VVTA RFP 2023-03
VICTORVILLE TRANSPORTATION CENTER RENOVATION
ADDENDUM NO. 4

Thursday, February 16, 2023

This addendum is provided to all known prospective proposers for clarification of the subject Request for Proposal (RFP).

PLUMBING FLOOR PLAN
 MULTI-MODAL TRANSPORTATION SERVICE CENTER FACILITY

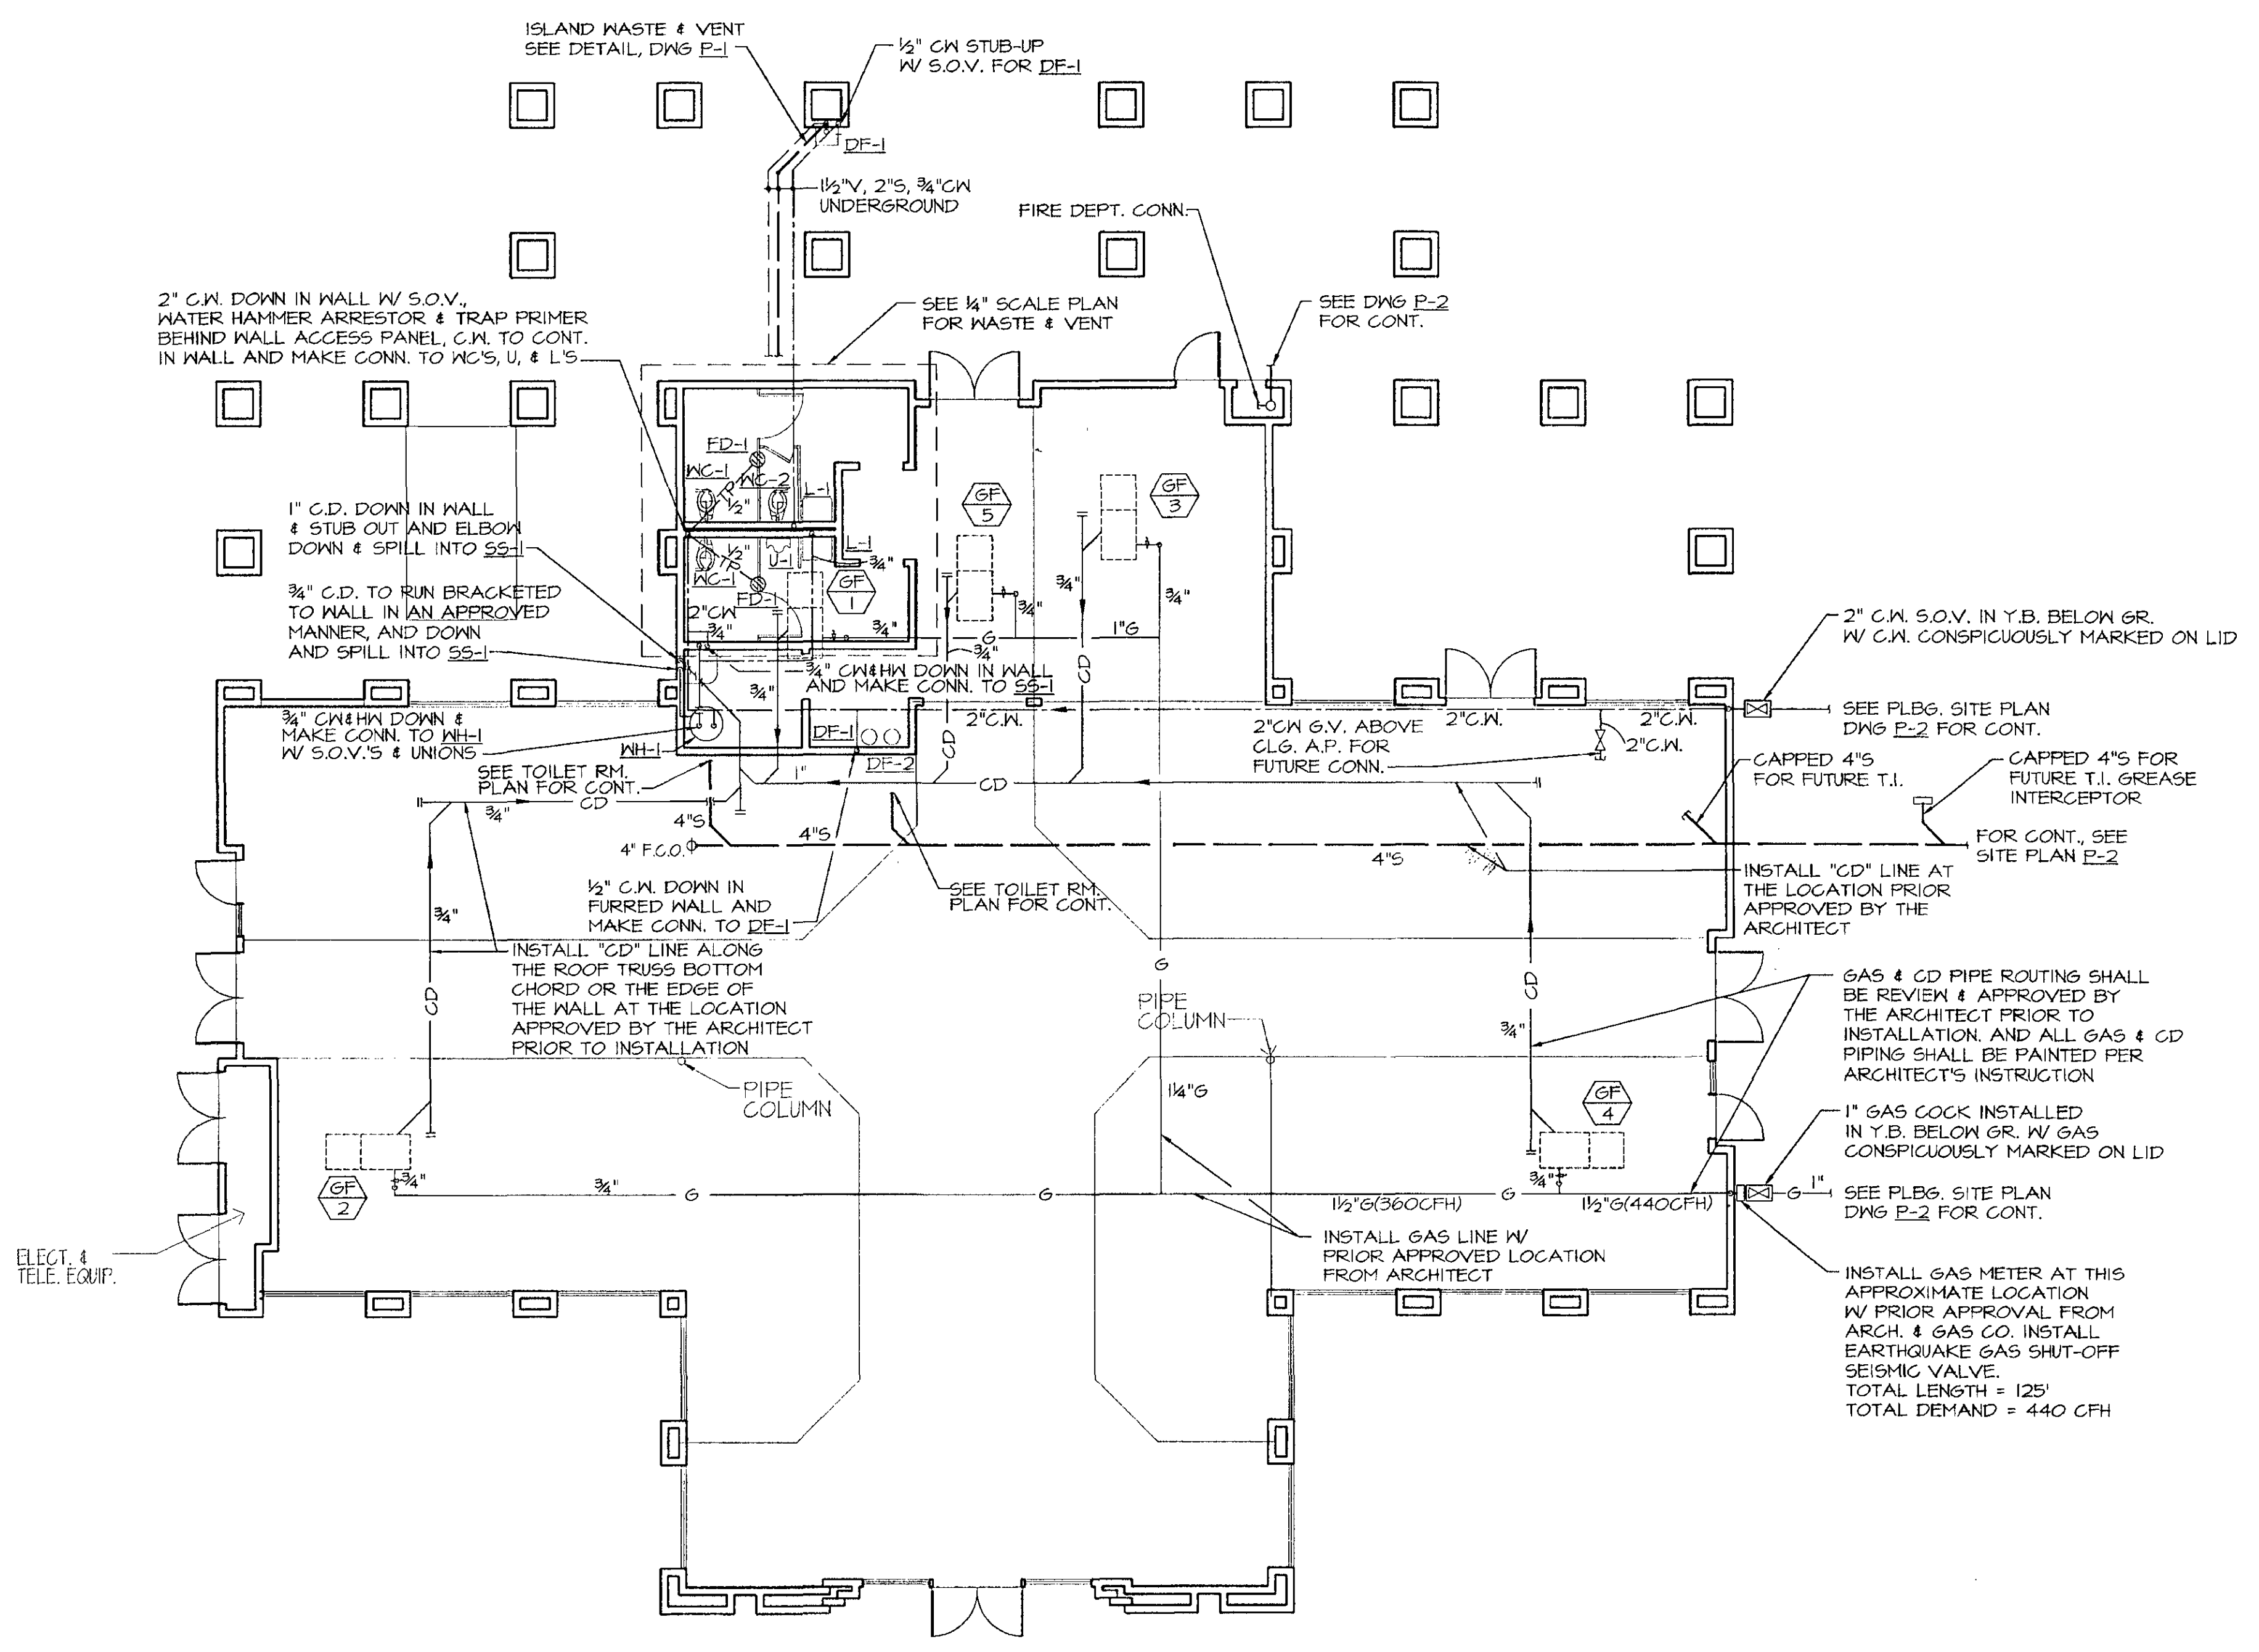
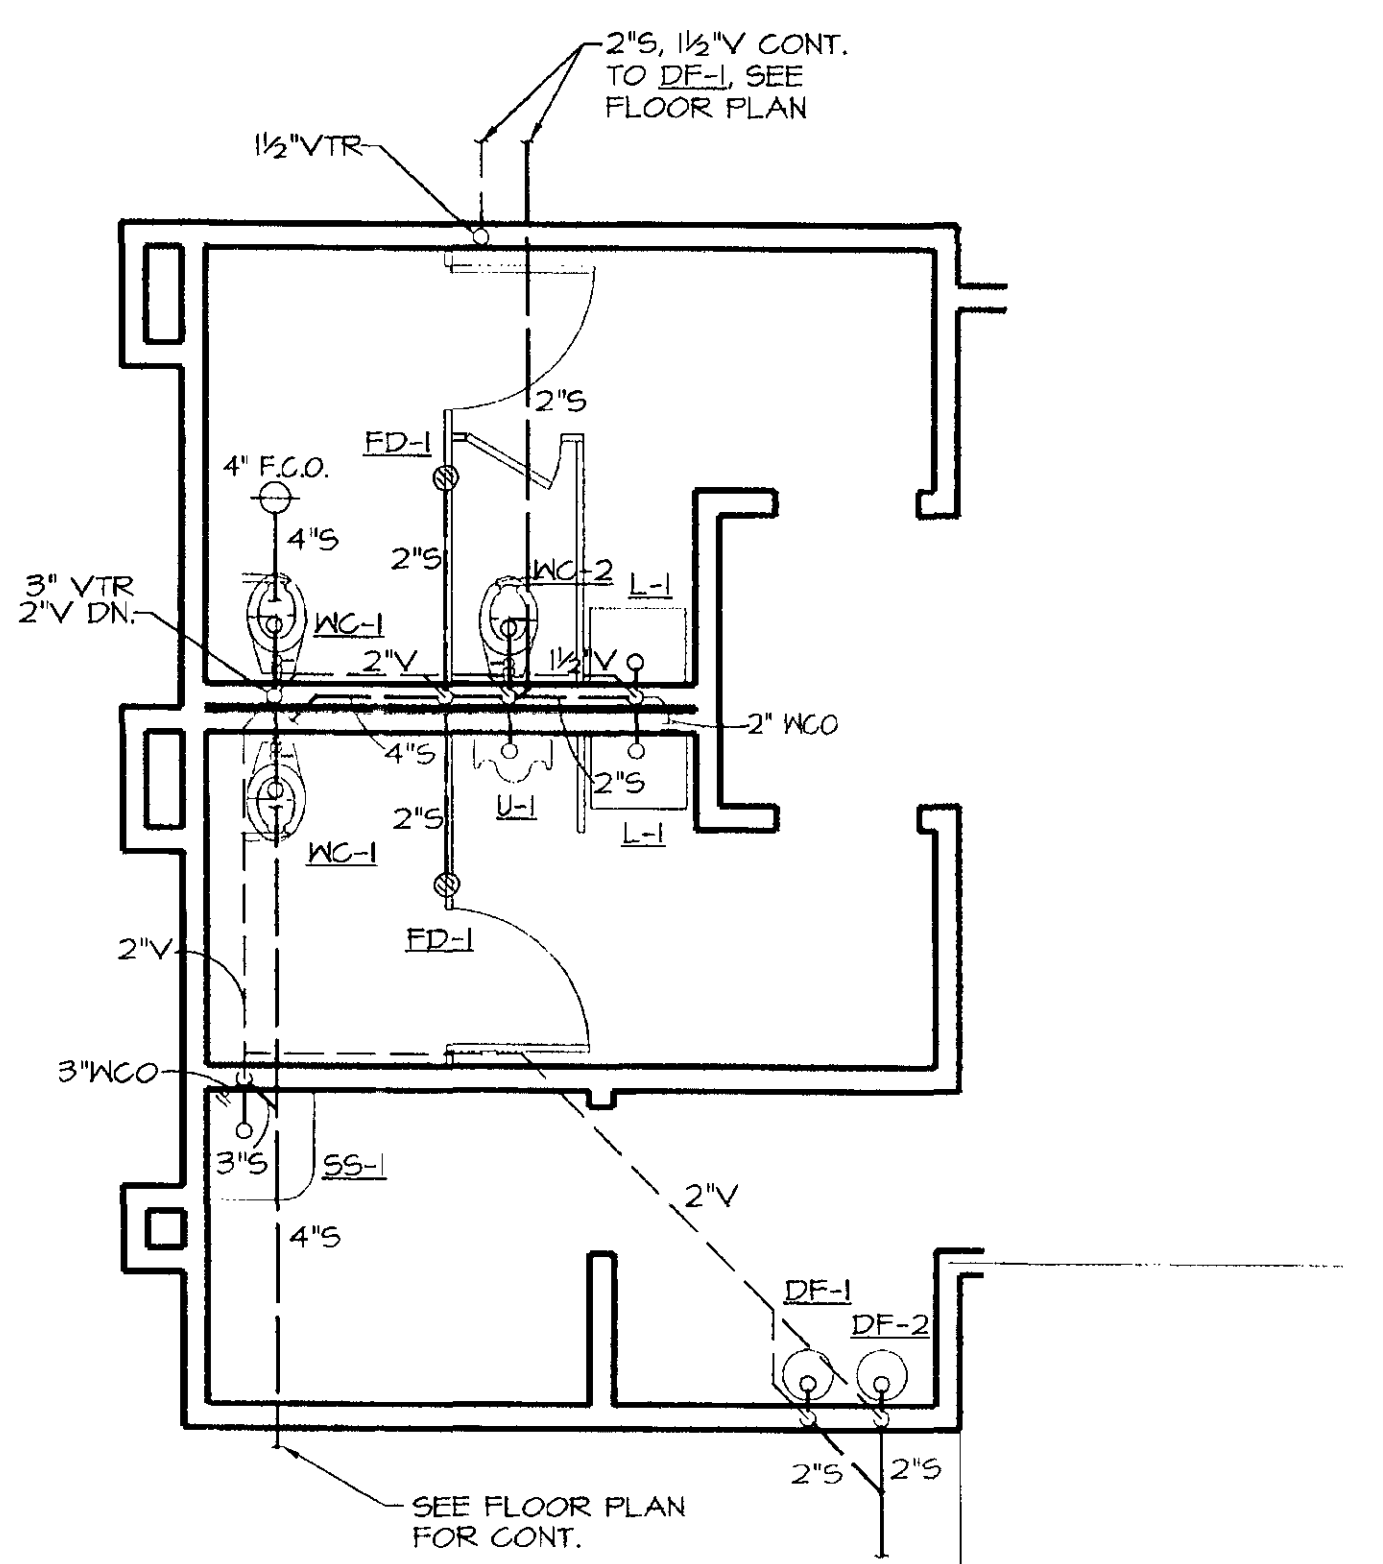
Q4: “What is the size of the existing sewer line that feeds the building?”

A4: According to the City of Victorville, the main line is 8” and a 4” lateral to the building. A drawing is attached referenced as “Exhibit 1.”
